Stonehill Offsite Water Extension Phase II
Solicitation Number: CO-00719
Job No.: 23-7003

ADDENDUM 2
November 21, 2023

C4.00 24" VERTICAL RISER DETAIL
A N.T.S.

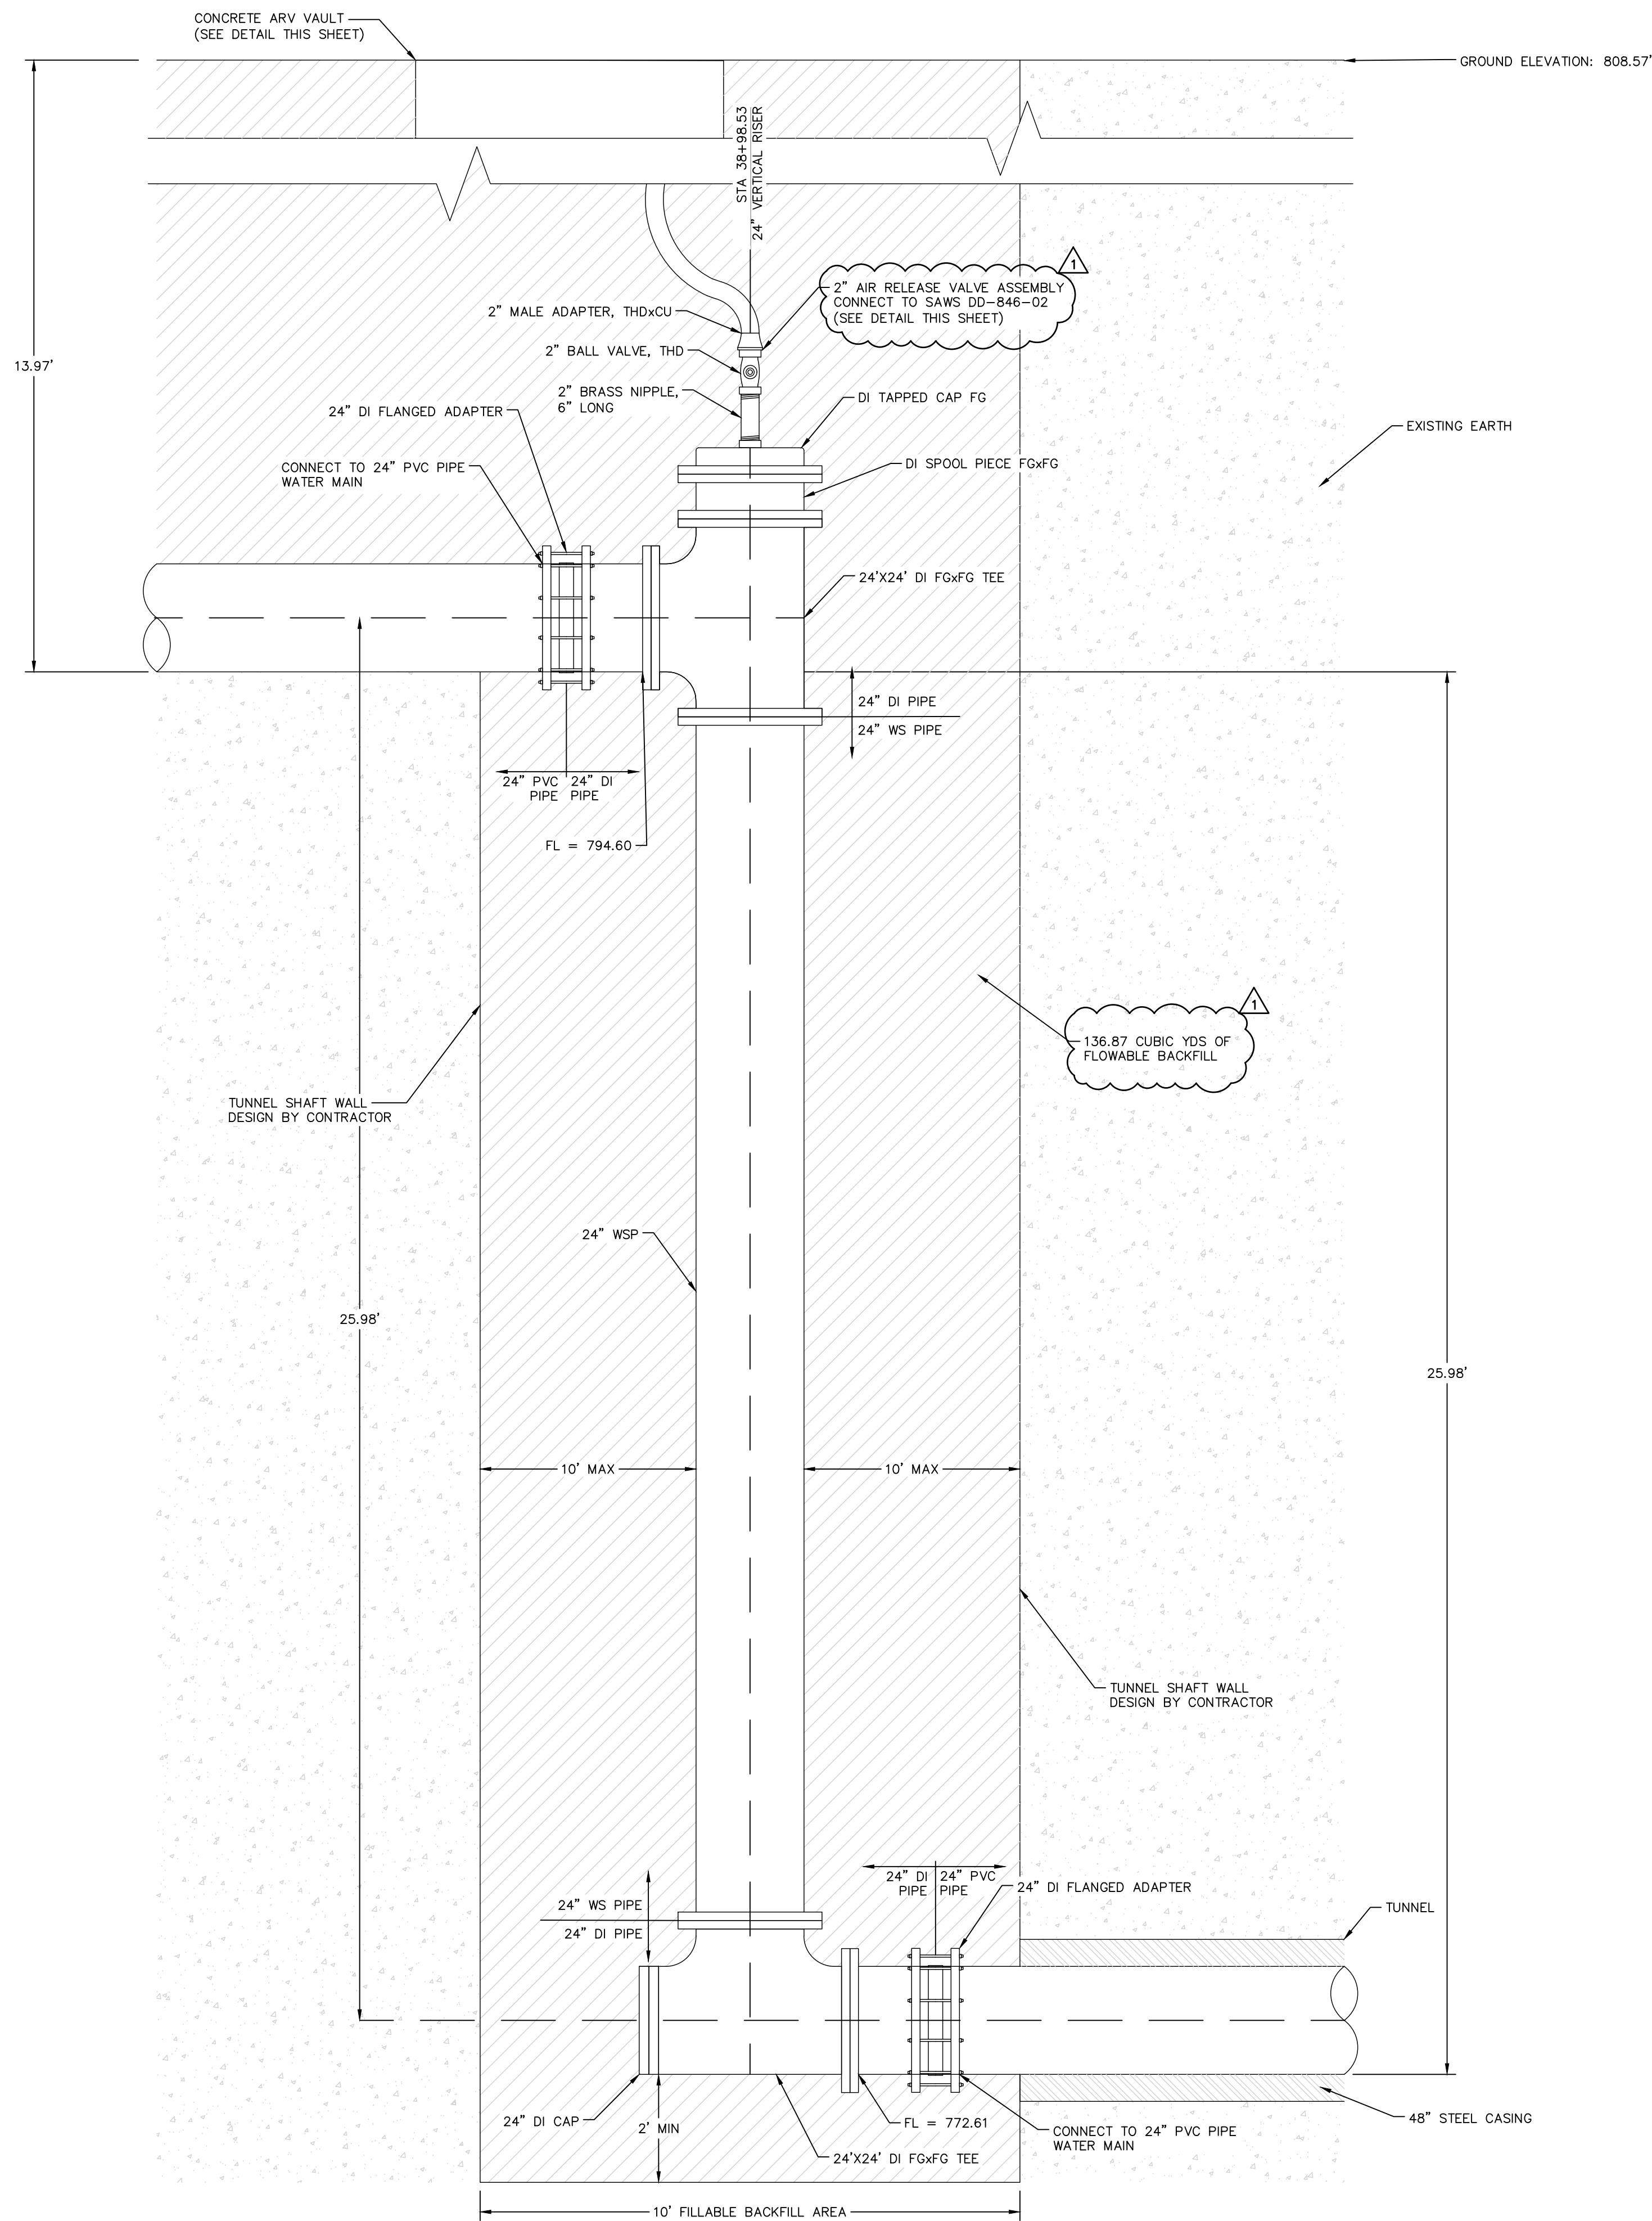
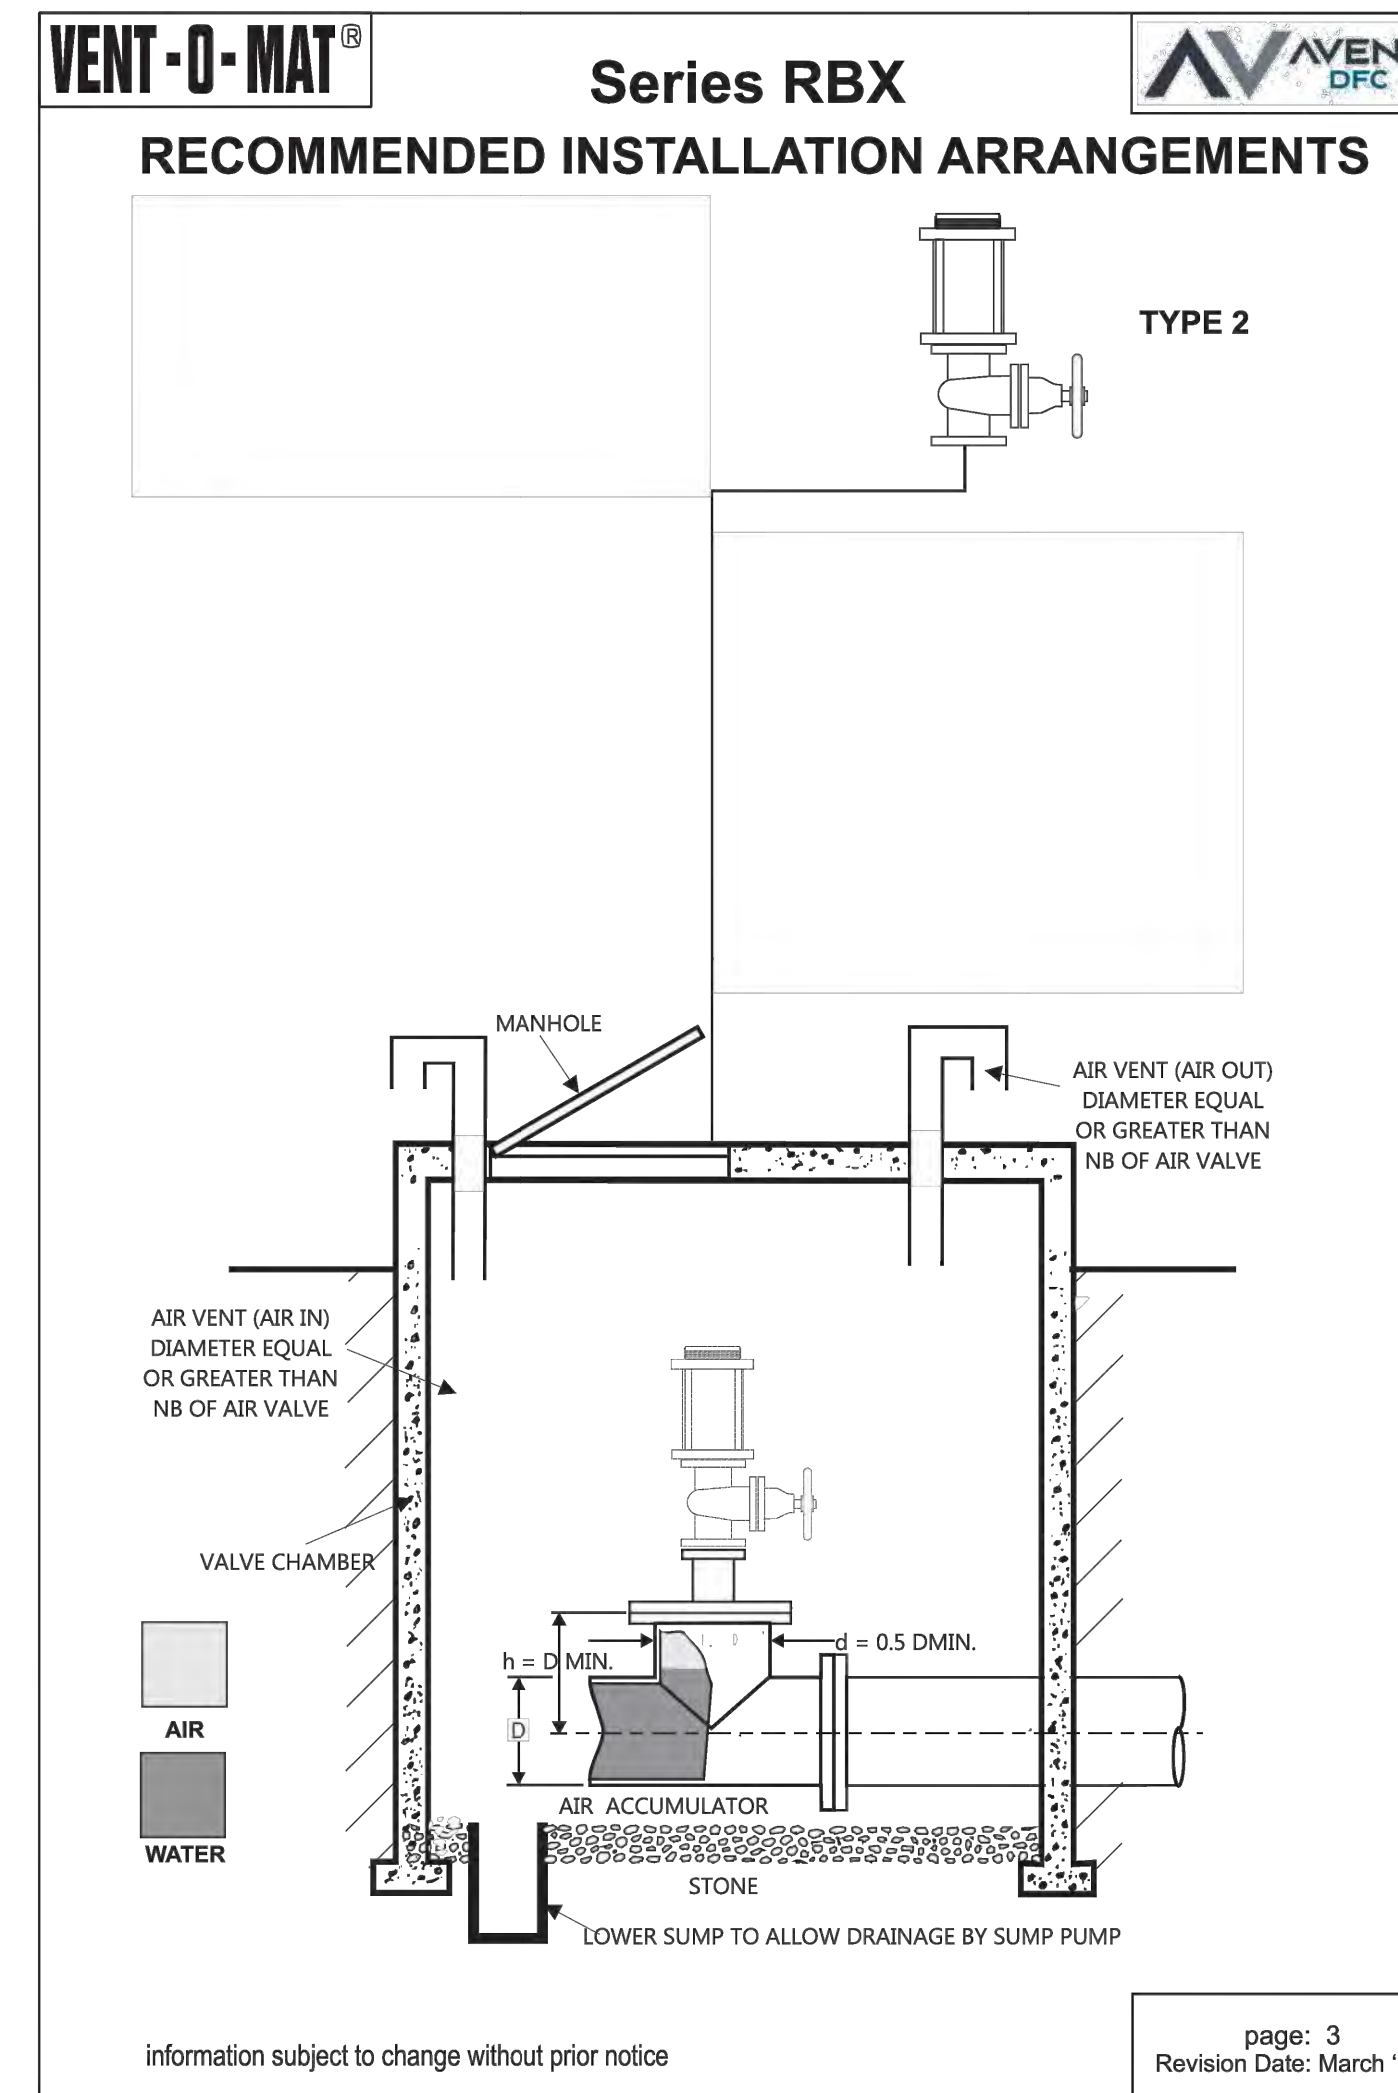
- 6. Question: On plan sheet C4.00 please clarify the size of the air valve. Detail A states 8" in size yet its attached to the 2" pipe nipples and a 2" ball valve. Also, if this air valve is to be 8" in size, under what bid item is it to go? The bid schedule only has a bid item for the 2" air valves.**

Response: See Changes to the Plans #3. The detail on sheet C4.00 has been revised to show a 2" ARV.
- 7. Question: The RBX model listed in detail B is stainless steel. Does that mean all of the other air valves have to be stainless steel as well?**

1. Remove sheet C1.01 and replace with the version included with this addendum. The quantities have been updated due to revisions referenced in the answers above.
2. Remove sheets C3.00 through C3.17 in their entirety and replace with the versions included with this addendum. Revisions have been made to the sizes of the blowoffs and all 16" valves have been revised to be MJ.
3. Remove sheet C4.00 and replace with the version included with this addendum. Detail A has been revised to show a 2" ARV.
